TUALATIN CITY COUNCIL

Wednesday, August 7, 2013

SUBJECT: CONTINUANCE- Consideration of a Central Urban Renewal District **Master Plan** for the Nyberg Rivers Shopping Center Development located at 7455-7925 SW Nyberg Street (Tax Map 2S124A 2700--2S124A 1601, 1602, 1900, 2502, 2506, 2507, 2700/ 2S124B 2000, 2001, 2100) in the Central Commercial (CC), Commercial Office (CO) and High-Density Residential (RH) Planning Districts and Central Urban Renewal Blocks 1-5 (MP 13-01).

Nyberg Rivers Master Plan Public Hearing

FIGURE 1
 Functional Classification
 Functional Classification Plan
 City of Tualatin Transportation System Plan
CH2M HILL
 Page 13

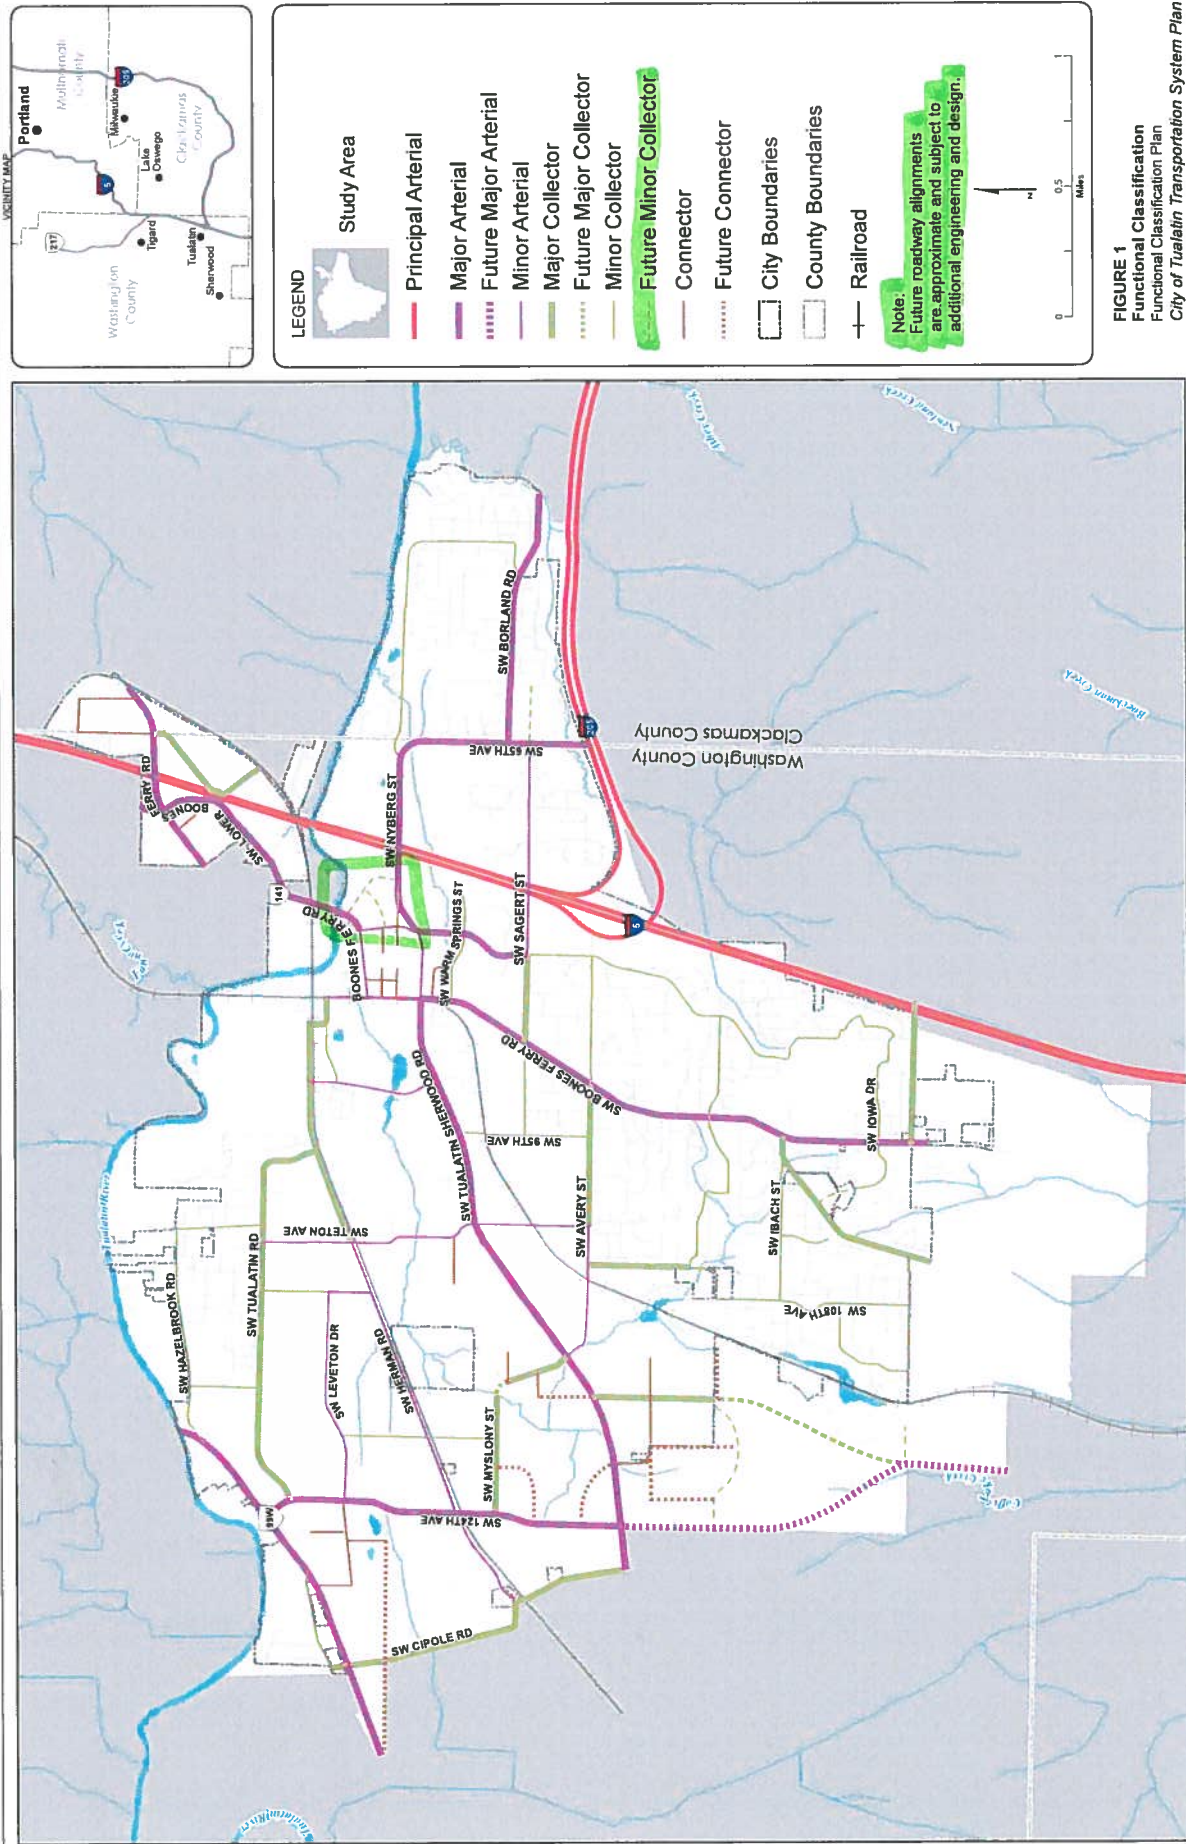
The applicant is providing a Loop Road in the location permitted by the TSP and has designed that road consistent with the terms of the Urban Renewal Plan. Exhibit 3, page 1 is an excerpt from the adopted TSP. Figure 1 shows a "future minor collector" on the project site. The future minor collector is shown as a dashed green line that connects Boones Ferry with

The TSP further provides that the function of this minor collector is to “connect two major arterials, SW Boones Ferry Road and SW Nyberg Street.” (Exhibit 3, page 2). The TSP Figure 1 shows the additional task of connecting Seneca Street to Boones Ferry and SW Nyberg through the site.

EXHIBIT 5-2

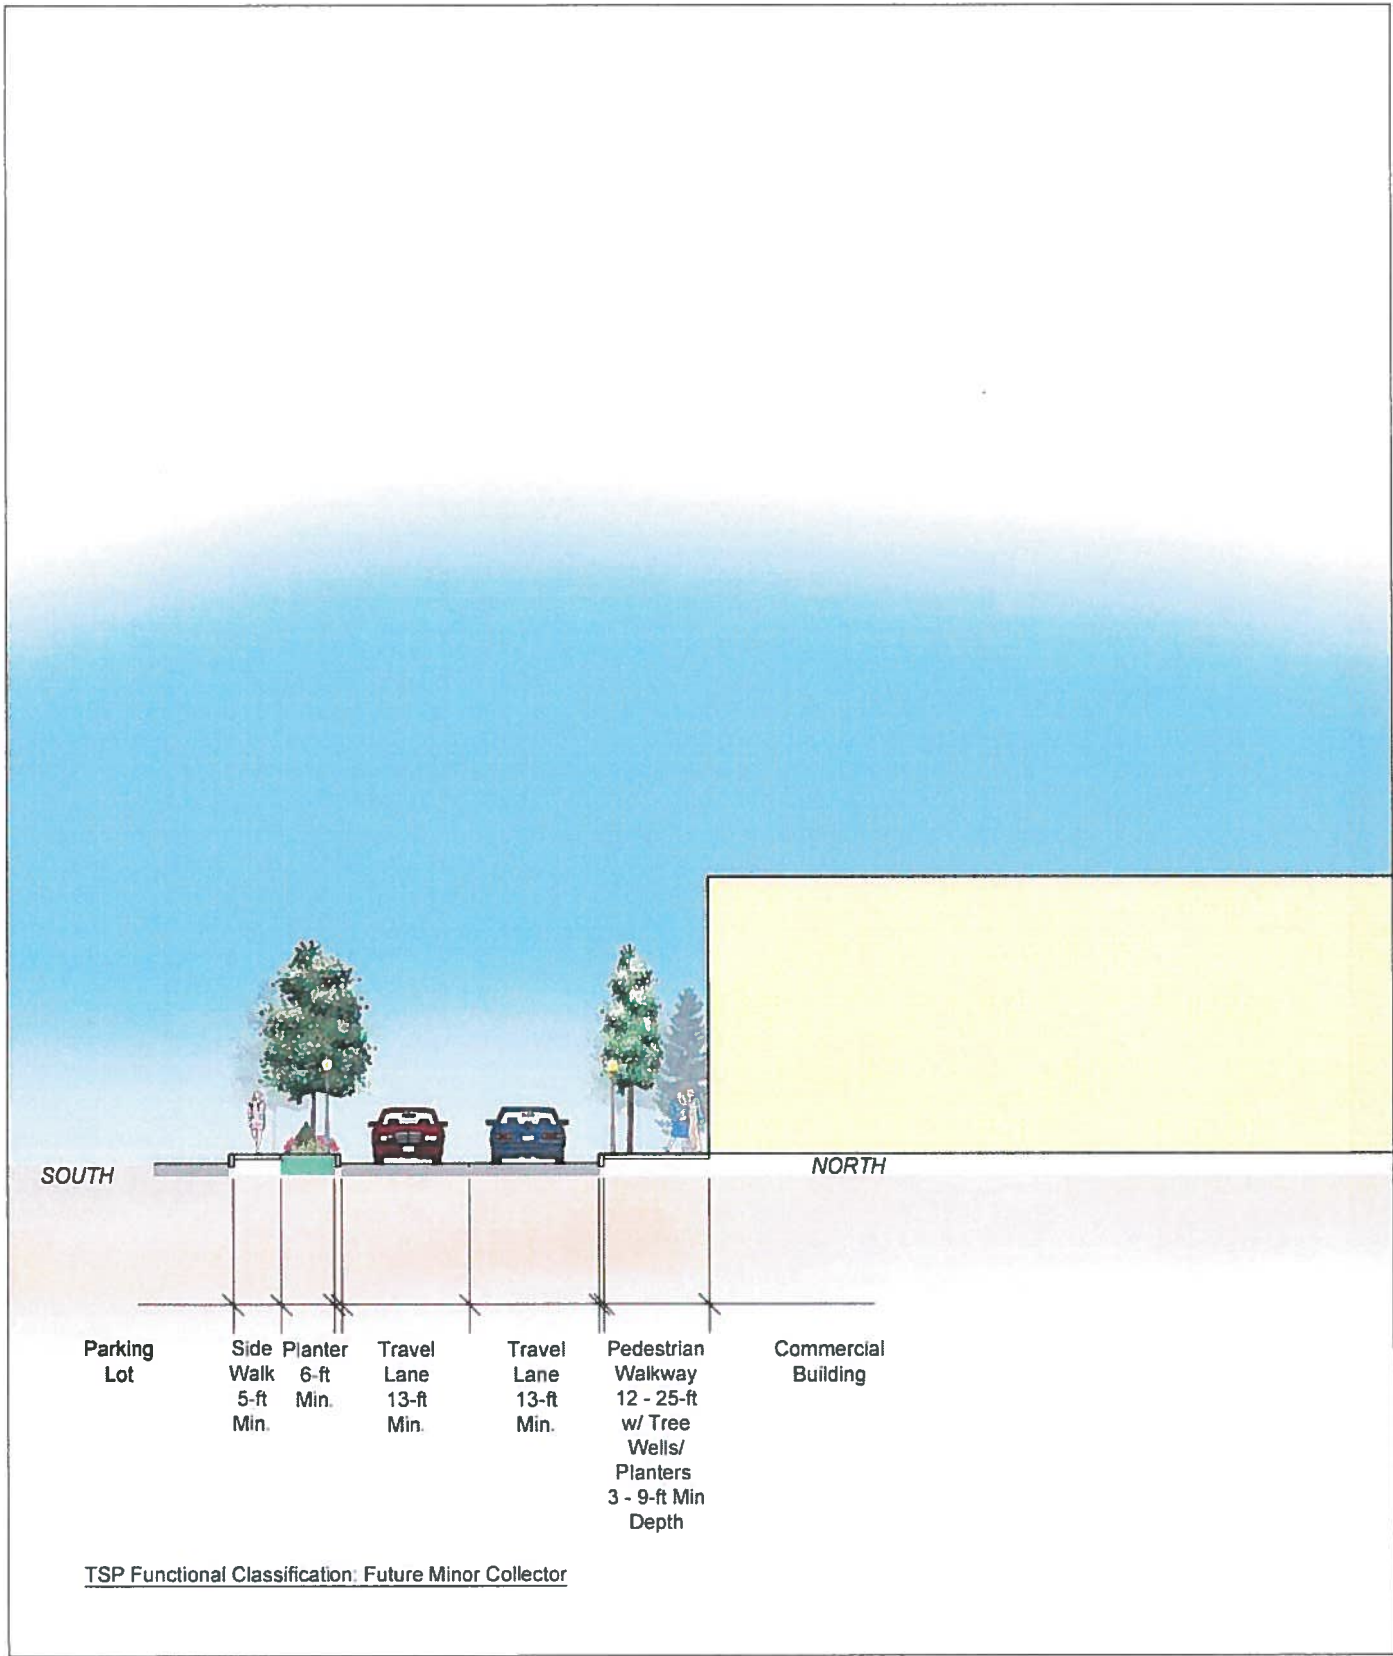
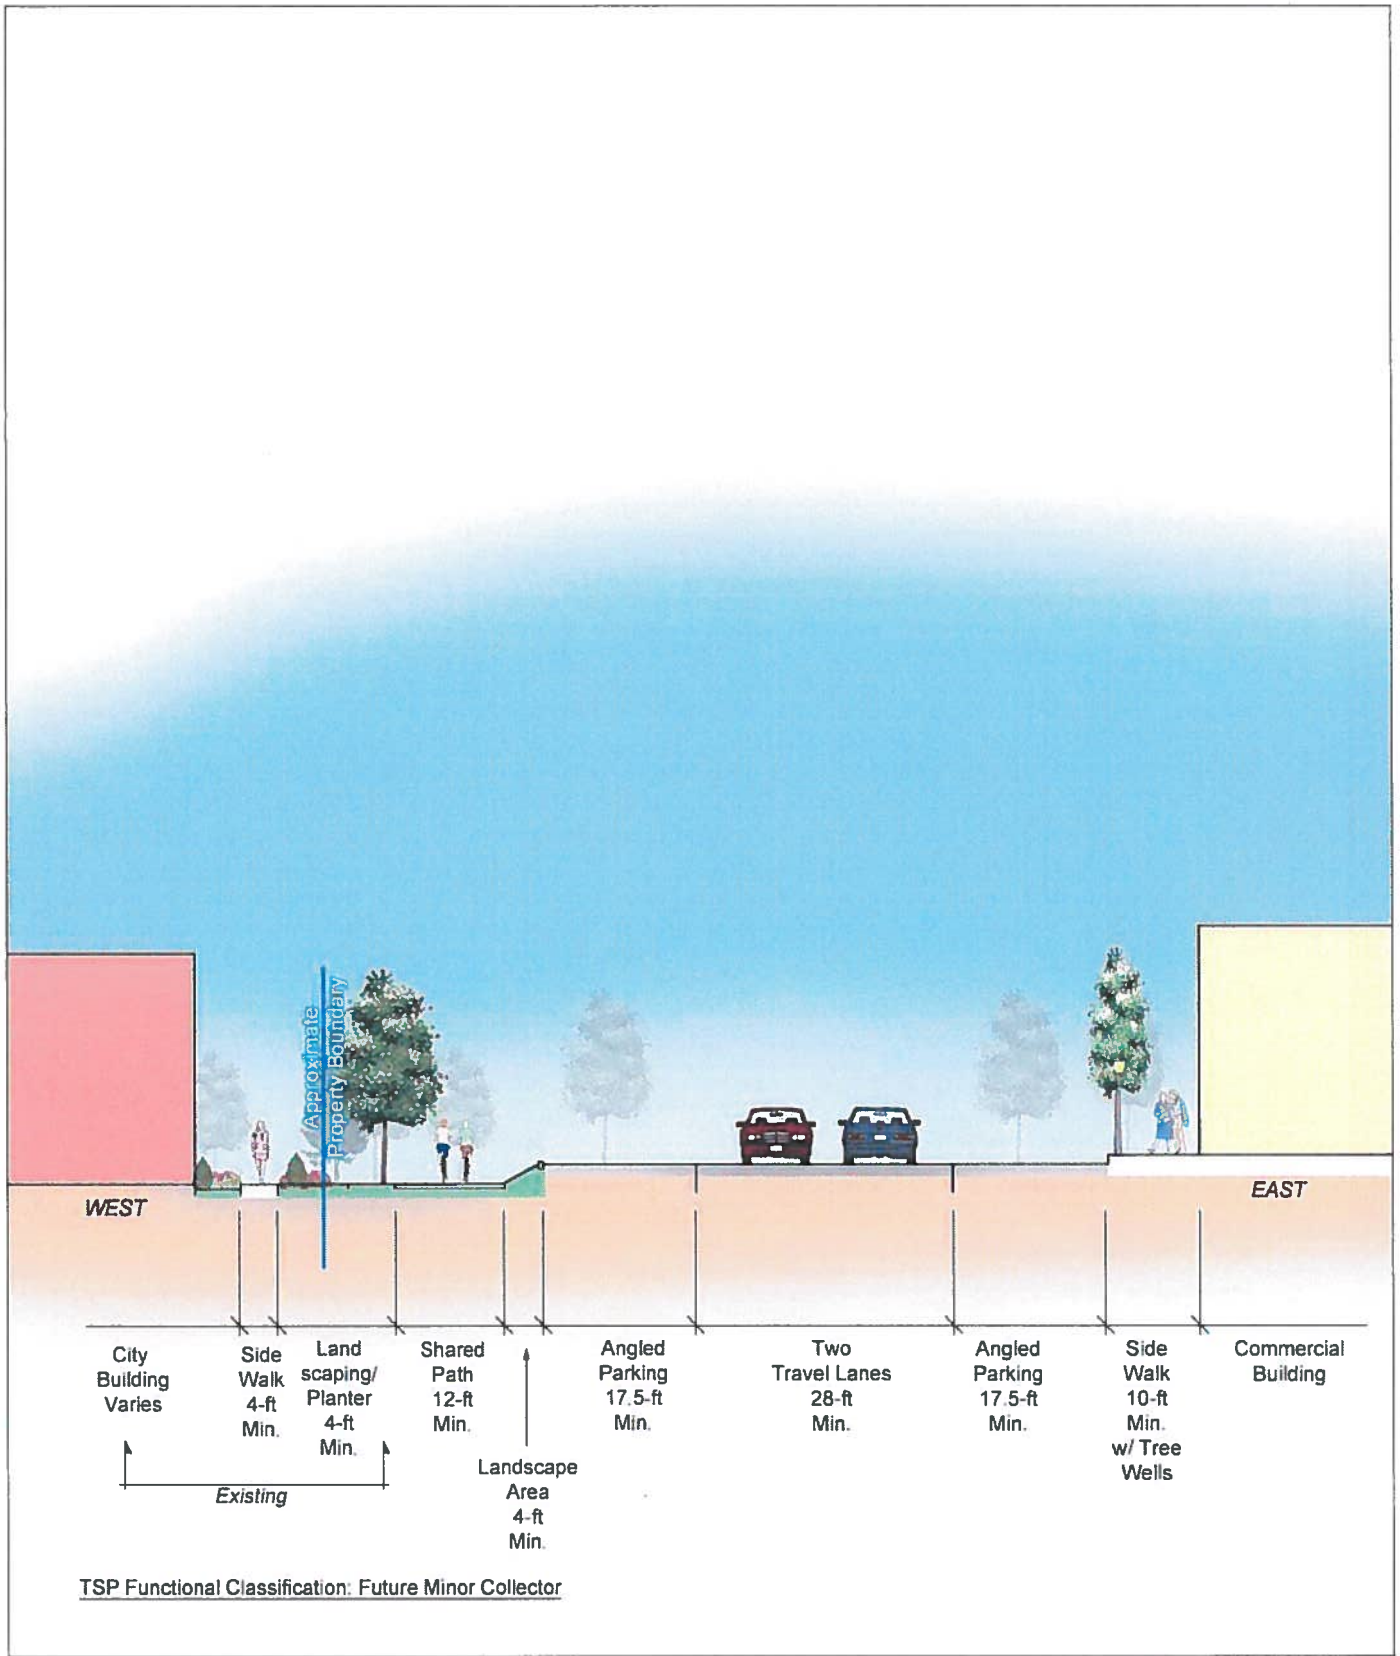
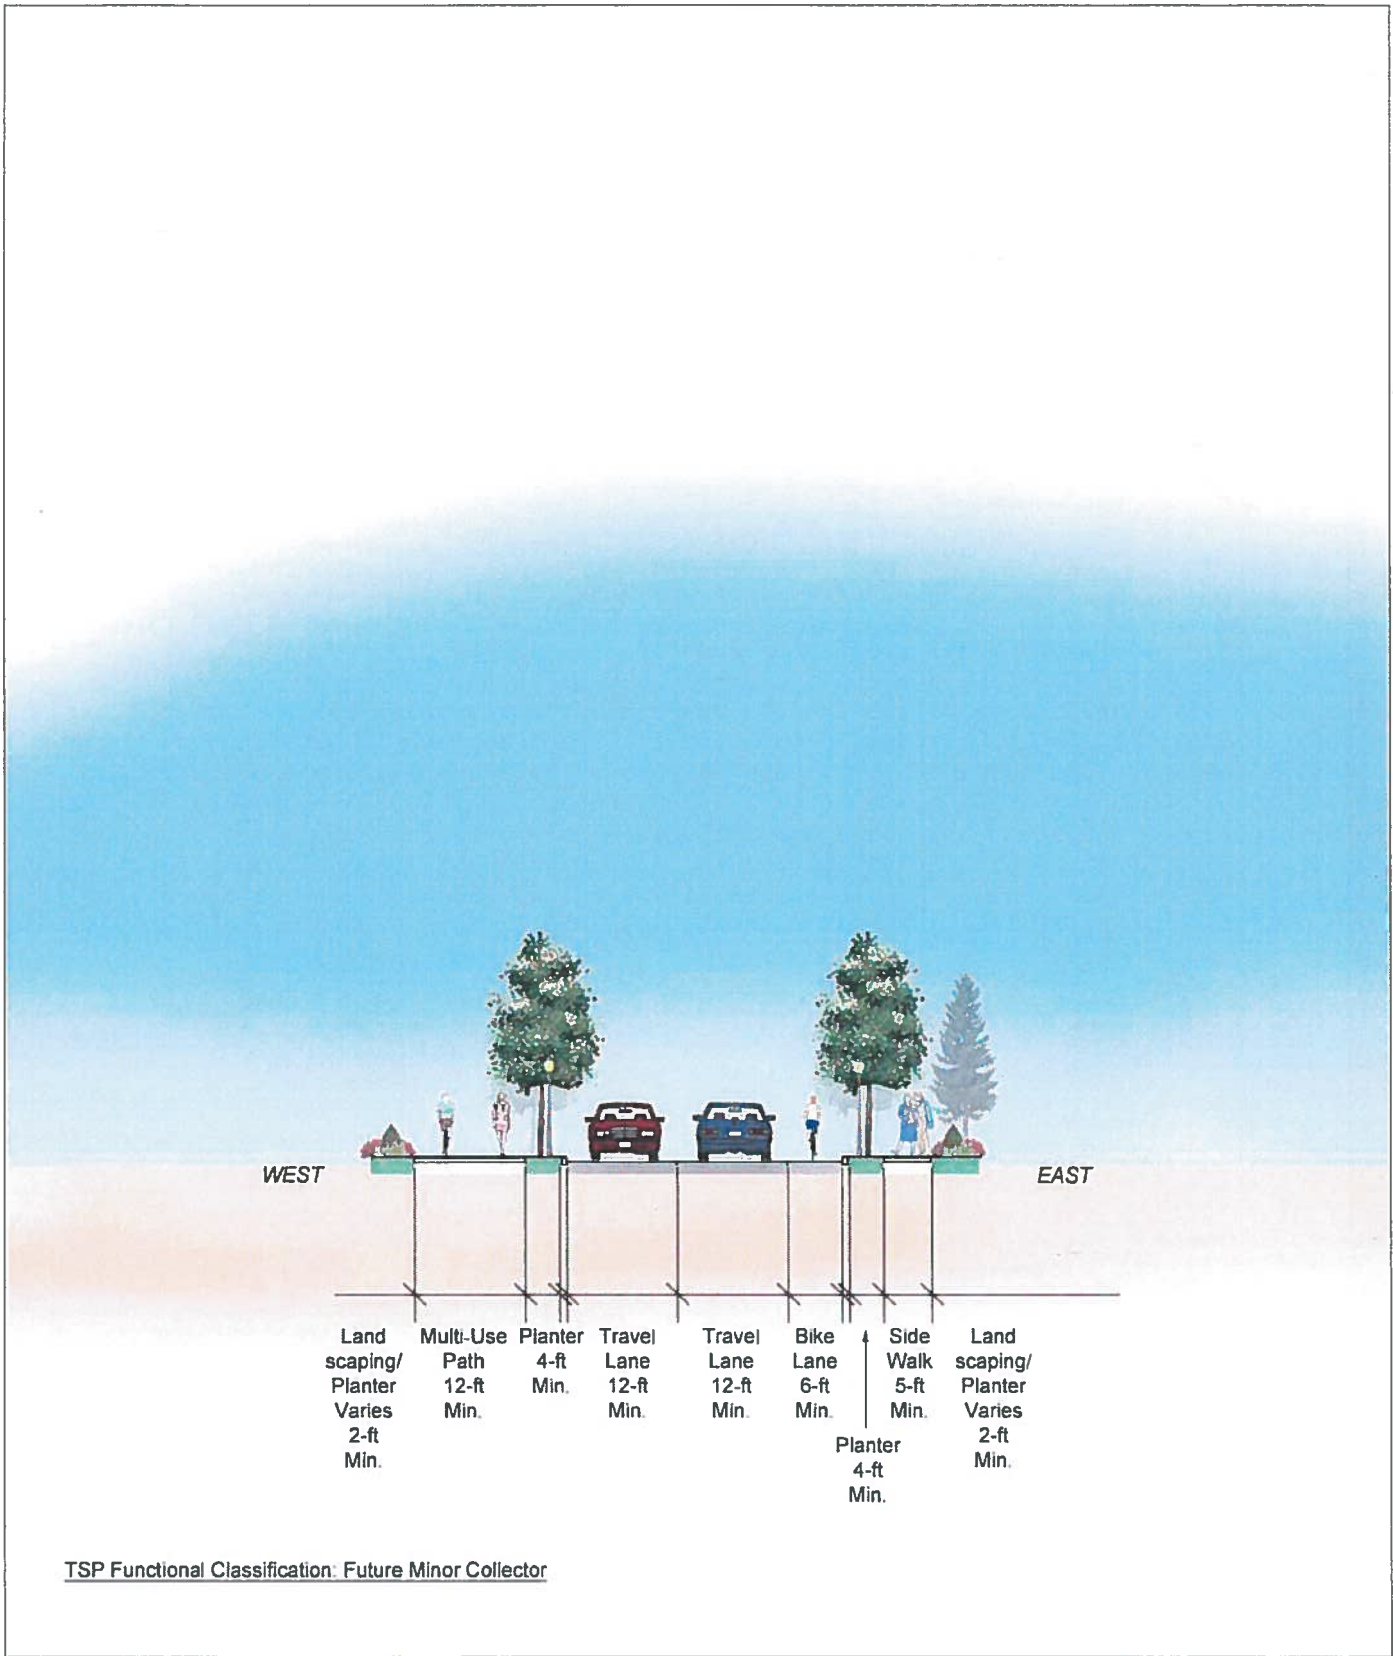
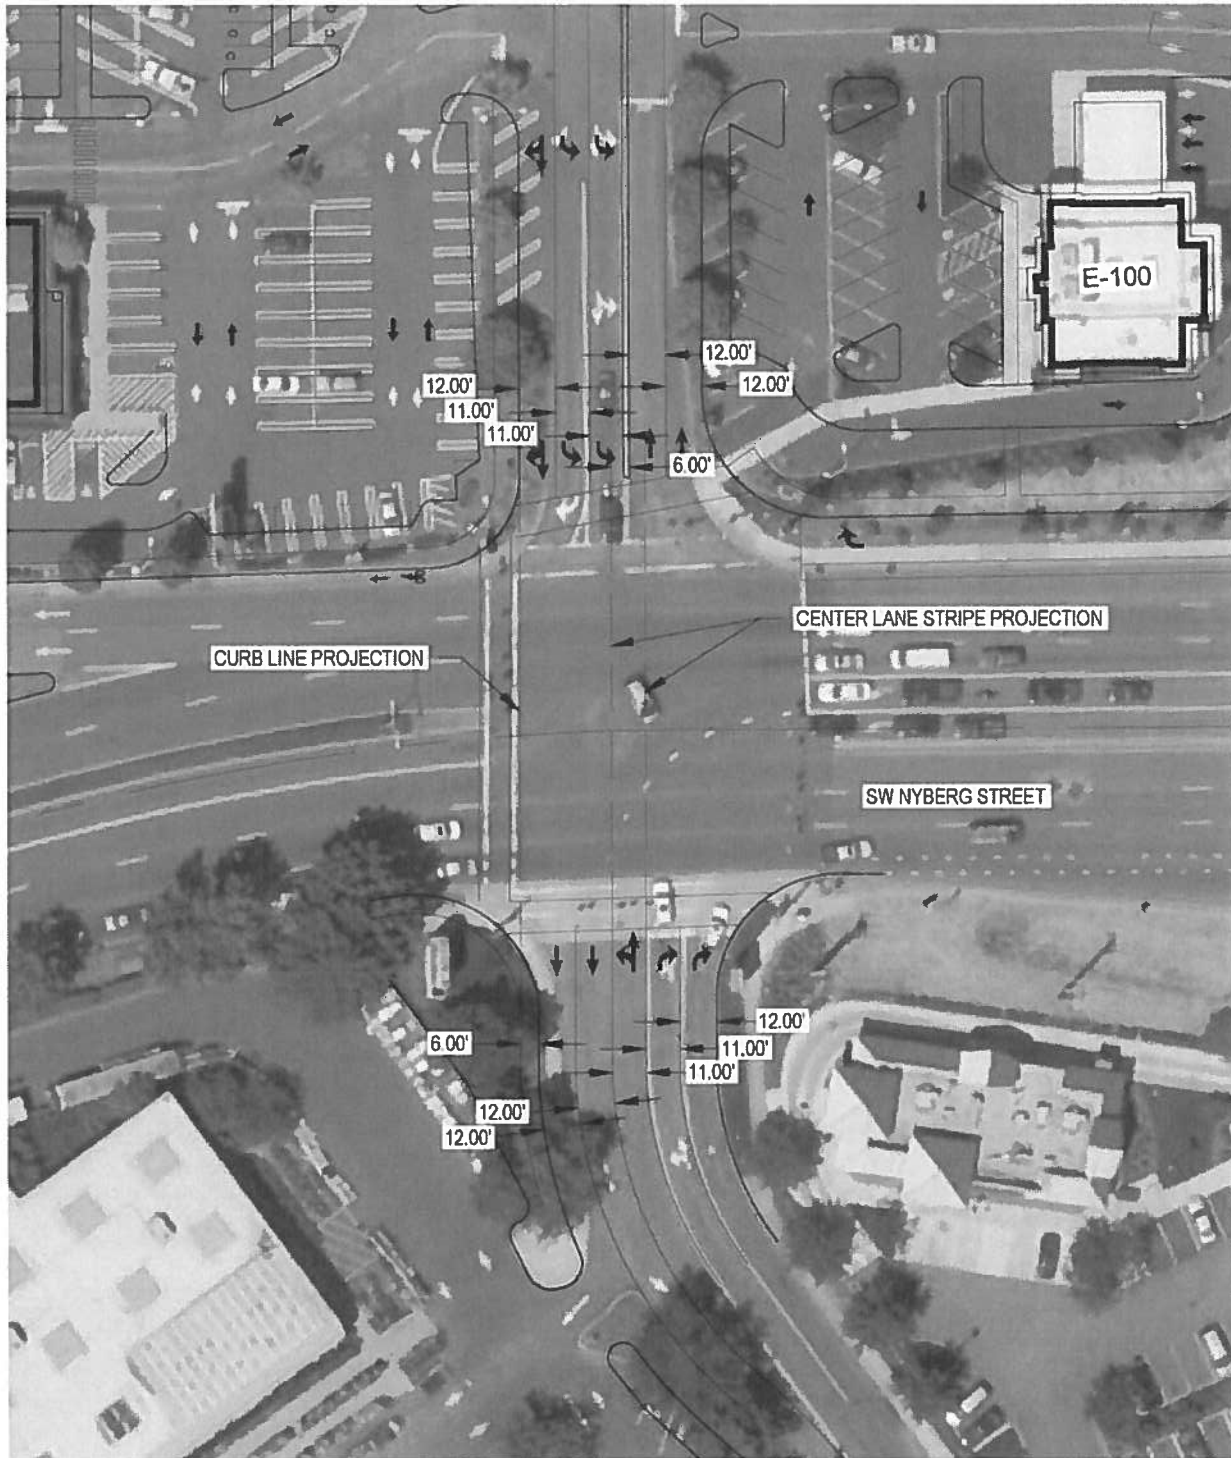
Here, the proposed Loop Road cross sections are consistent with the description of the Loop Road in the Urban Renewal Plan. Each cross section is attached as Exhibit 5. The cross sections provide sidewalks and/or shared paths, bike facilities, at least 2 travel lanes, and landscaped planter areas. In some cases, these cross sections provide even greater ultimate width than is shown in Minor Collector Cb (75-2E).
